Docket No. 50-423
B12024

Millstone Nuclear Power Station, Unit No. 3
Response to Information Requested
Regarding Station Blackout
Technical Review

March, 1986

FIGURE 2.1-2. Reactor vessel mixture level - 300 gpm/RCP leakage without secondary depressurization.

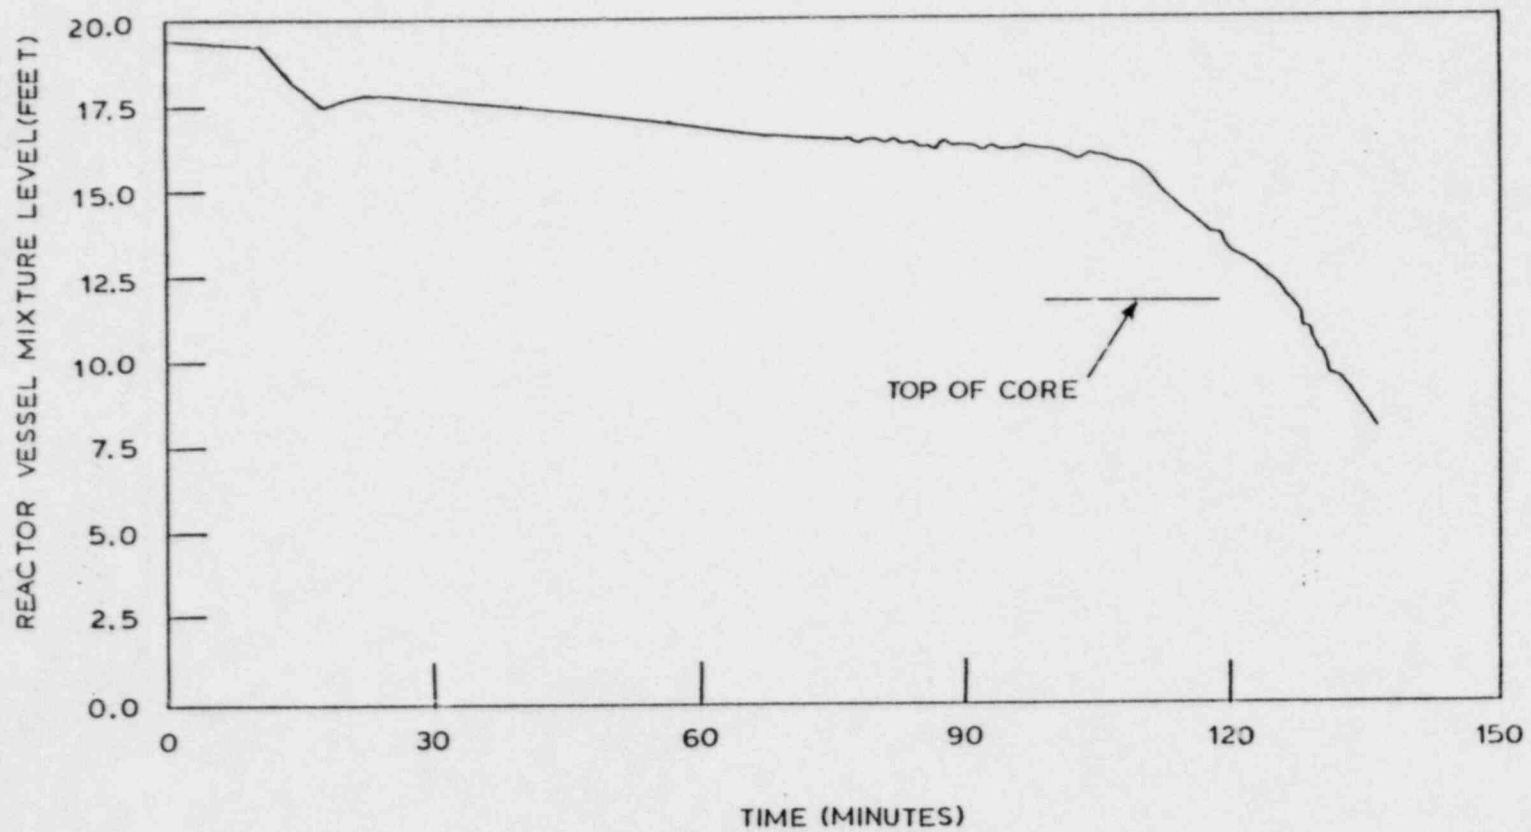
This is two times faster than physically possible. Even assuming a 300 gpm/RCP seal leak, plant specific best-estimate analysis performed as a part of the Millstone Unit 3 Probabilistic Safety Study indicates at least two hours being available before the onset of core uncovery. Figure 2.1-2 shows the actual reactor vessel water level as a function of time assuming no cooldown. If the secondary plant is depressurized after one hour (References 5,6), the time until the onset of core uncovery is increased out to three hours as shown in Figure 2.1-3. Figure 2.1-4 shows the predicted times to core uncovery at Millstone Unit 3 both with and without cooldown at 100^oF/hr. Overlaid on this figure is the NRC Staff's assumed value.

FIGURE 2.1-5. RCS pressure - 300 gpm/RCP leakage with secondary depressurization.

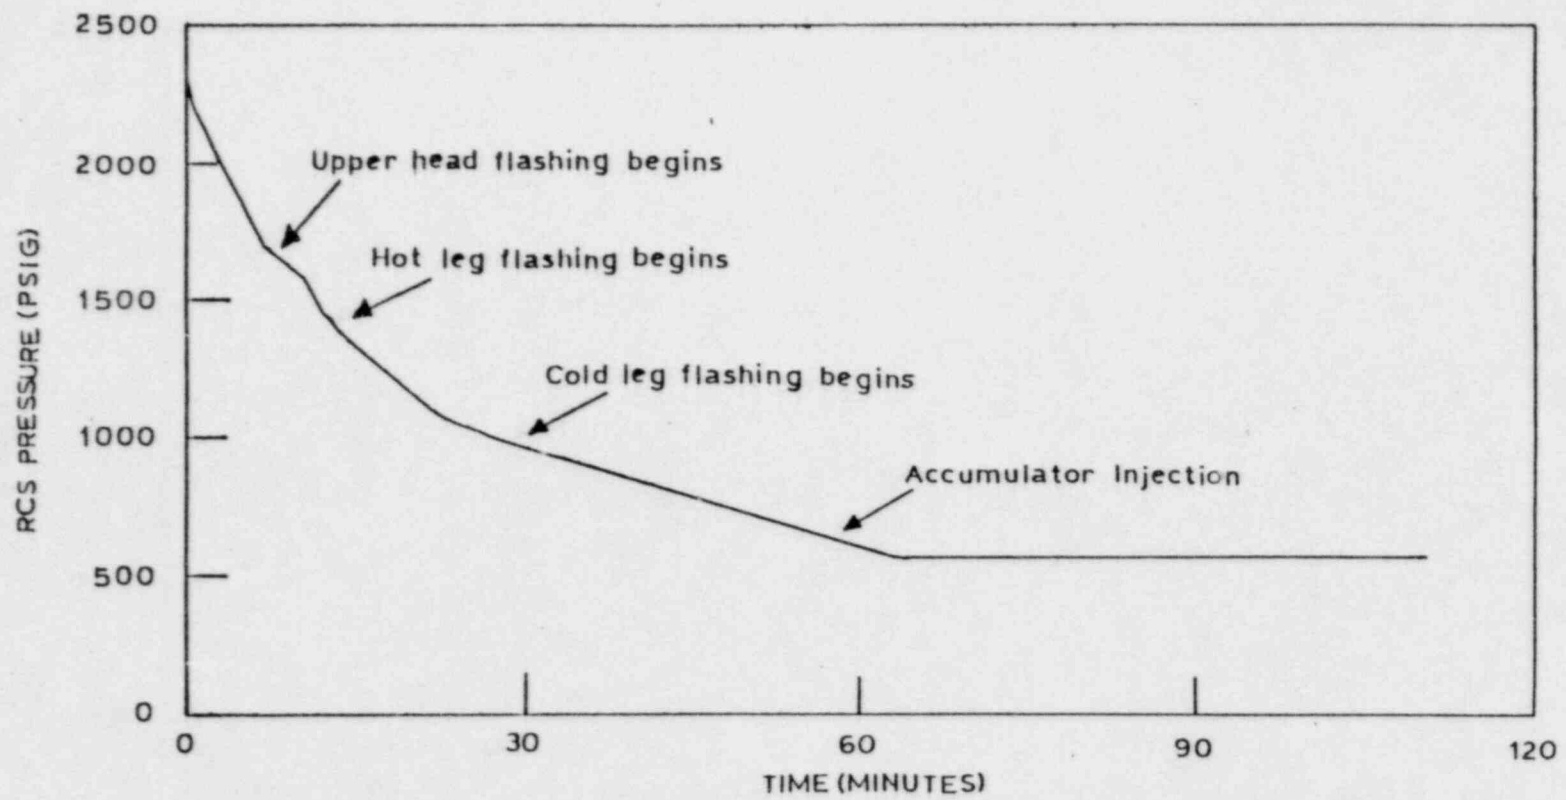
Under Station AC Blackout conditions and no capability to run the charging pumps, the cooldown is procedurally terminated at about 450°F to prevent pressurized nitrogen gas from the Accumulators being discharged into the RCS. Figure 2.1-5 shows the anticipated pressure response during a depressurization scenario following a Station AC Blackout. Figure 2.1-6 shows the anticipated temperature response during a depressurization scenario following a Station AC Blackout.

FIGURE 2.2-1. Time line for NUREG-1152 case (a)

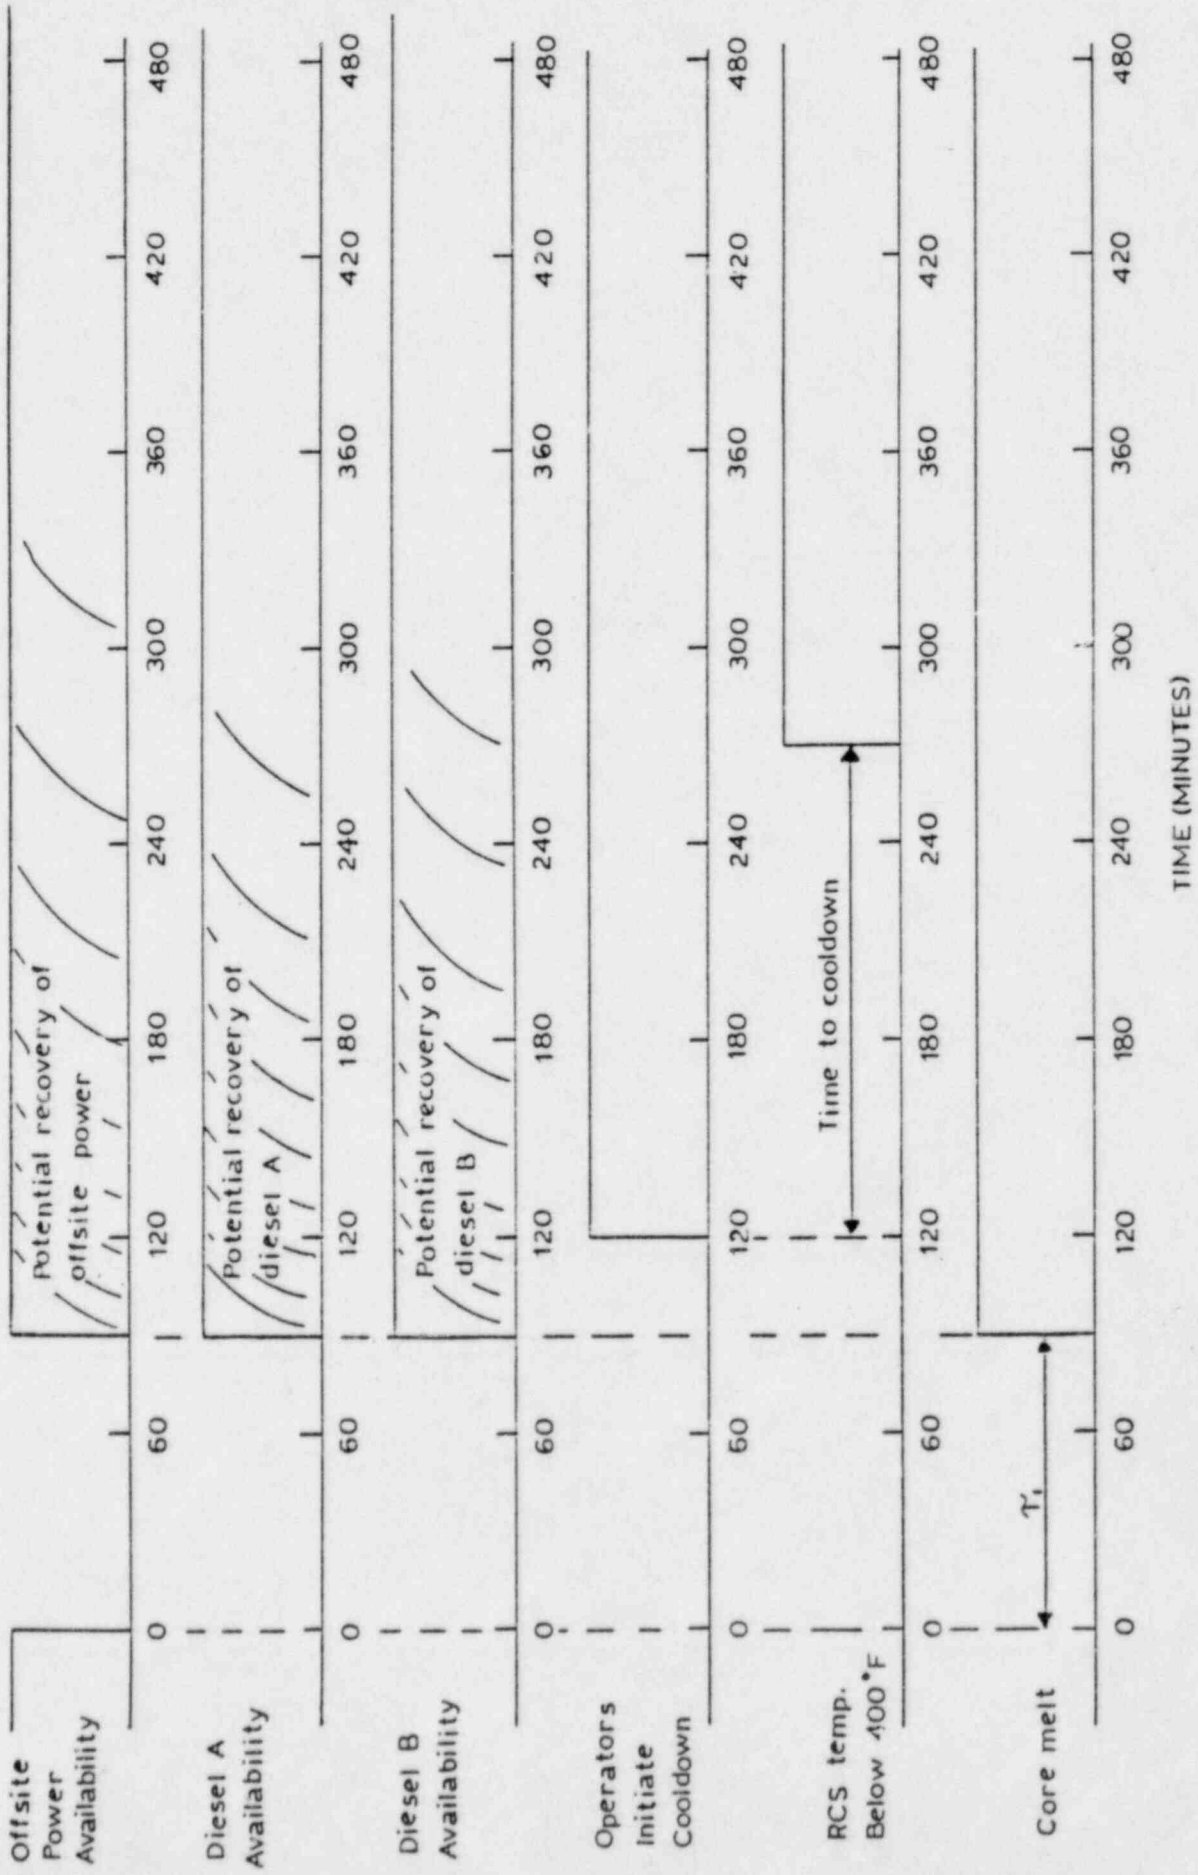
The above noted model fails to account for this.

The second portion of the probability equation makes an implicit assumption that the maintenance unavailability of one of the diesels is initiated concurrent with the loss of offsite power and the failure to start event in the other diesel. This does not seem realistic. A more realistic scenario would involve the initiation of a maintenance

FIGURE 2.2-2. Time line for NUREG-1152 case (b) (short term scenario)

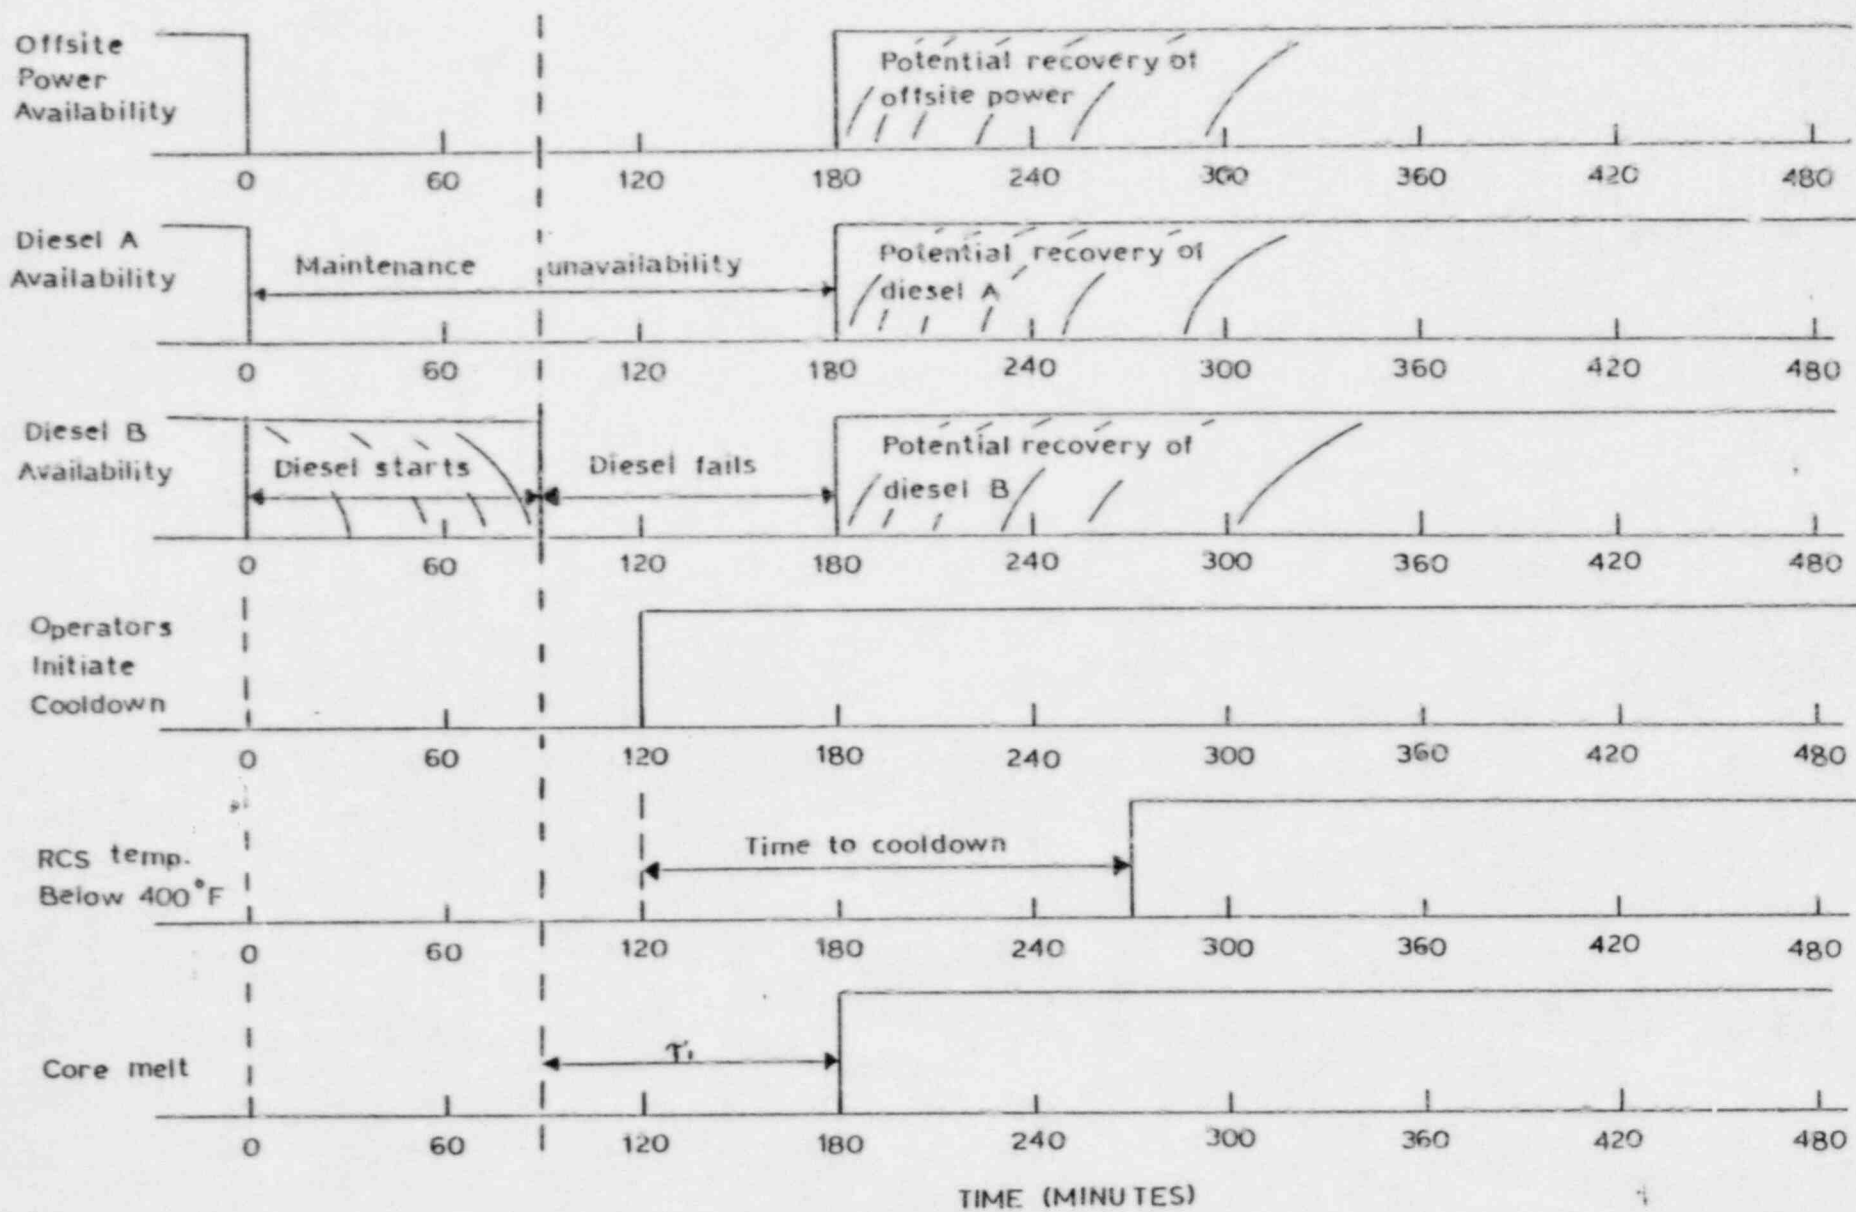
The split integration limits on the convolution integrals are based on an incorrect assumption related to the ability to cooldown below 400°F during Station AC Blackout. The first term addresses core melt due to early RCP seal leakage. The second term is based on Station DC Blackout and assumes in long time scenarios (>4 hours) that the RCS is cooled down below 400°F. As discussed in Section 2.1, this assumption is not credible.

There is again an unstated assumption in this equation that the maintenance unavailability of one of the diesels starts at the same time that the loss of offsite power event occurs. This does not appear to be realistic. A more likely scenario would be one where the loss of offsite power event occurred somewhere in the middle of a diesel maintenance unavailability. If the maintenance outage of the diesel started before the loss of offsite power, such an outage would end earlier and thereby reduce the duration of the Station AC Blackout.

Again, as noted with Case (a), the "grace time" should be treated as a random variable rather than a conservatively estimated fixed parameter. The revised equation should read as follows:

FIGURE 2.2-3. Time line for NUREG-1152 Case (c) (short term scenario)

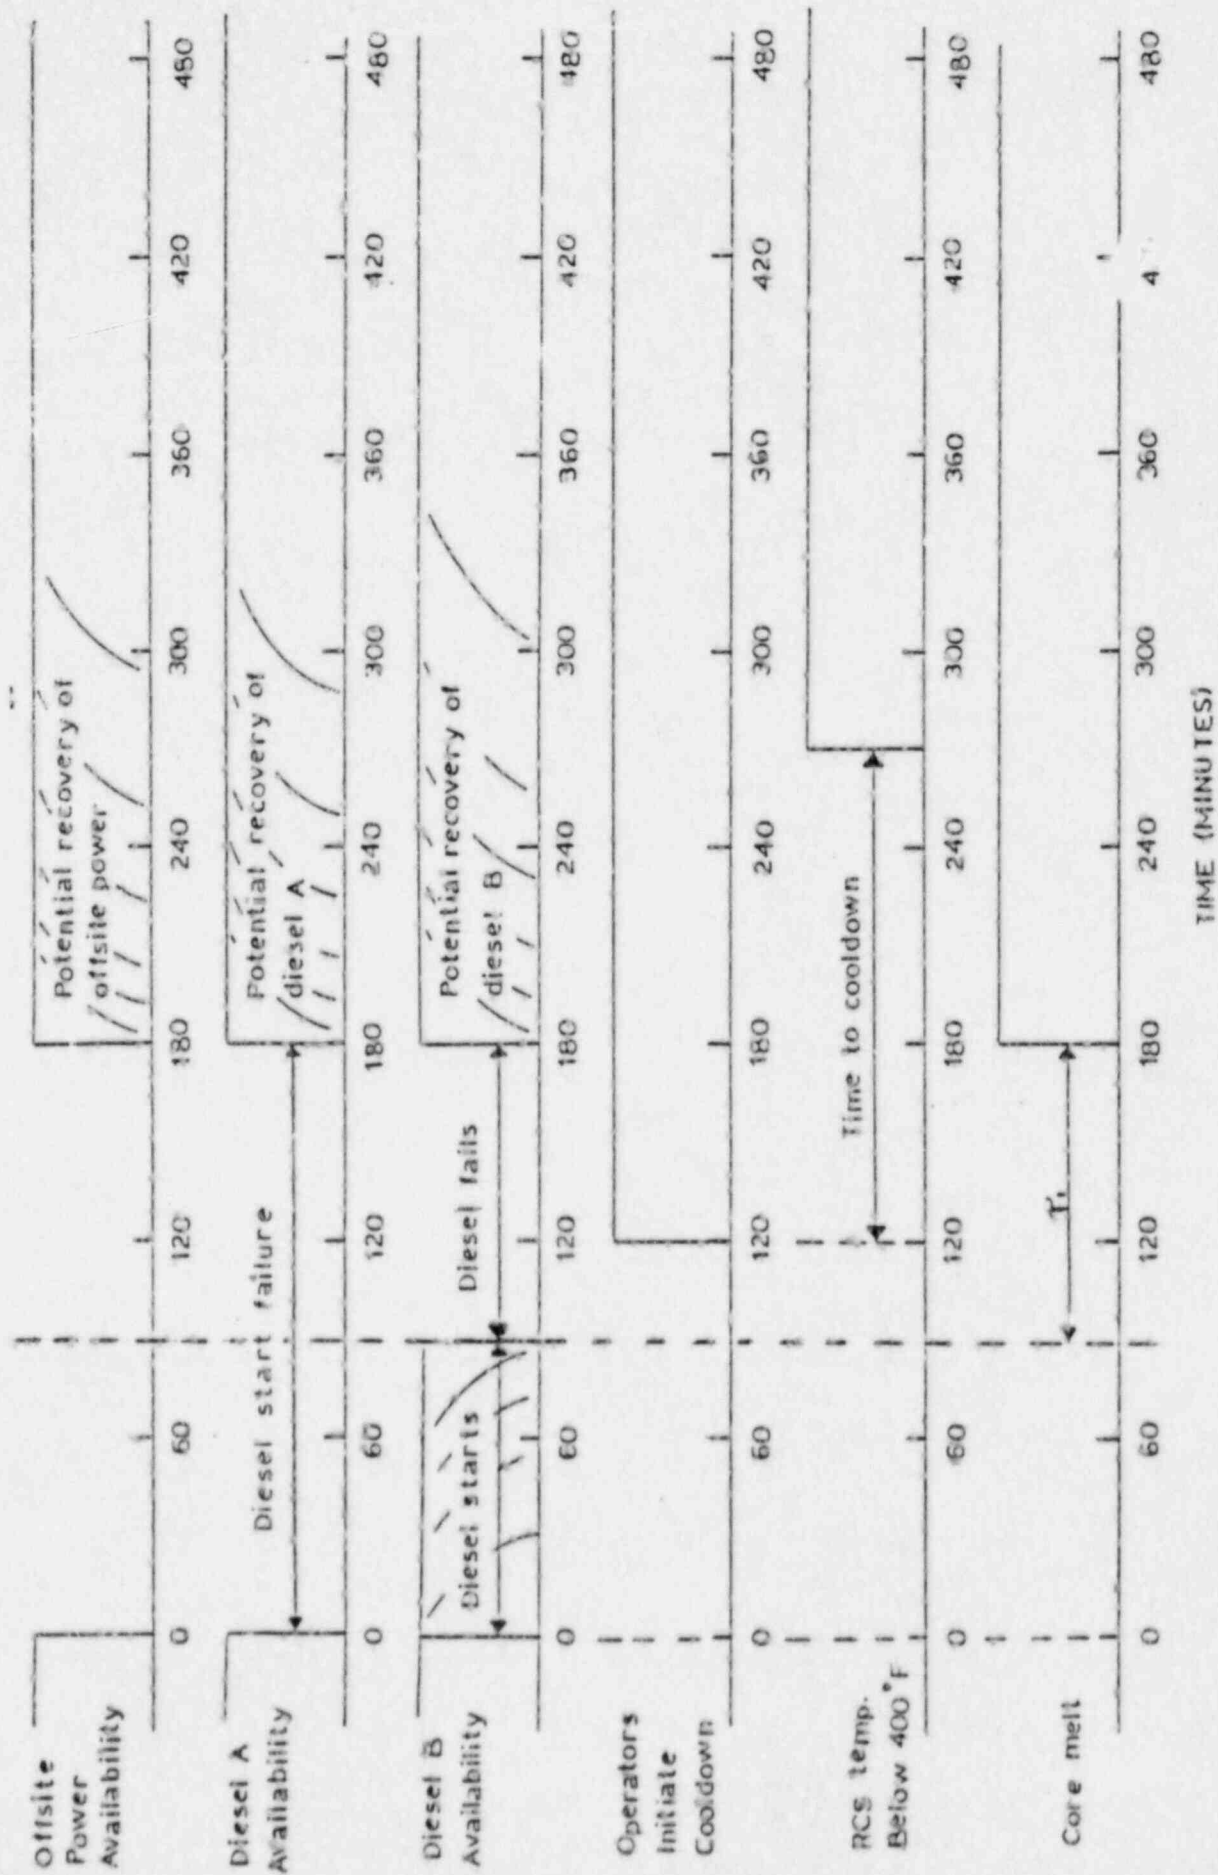
This case involves a loss of offsite power in which one diesel fails to start and the other diesel fails to run. Restoration of any of the emergency power sources is delayed to beyond the time of core melt onset. A time line diagram of this failure scenario is shown in Figure 2.2-3 along with key assumptions made by the NRC Staff.

The revised equation should read as follows:

Treating the "grace time" as a random variable results in a reduction in predicted core melt frequency.
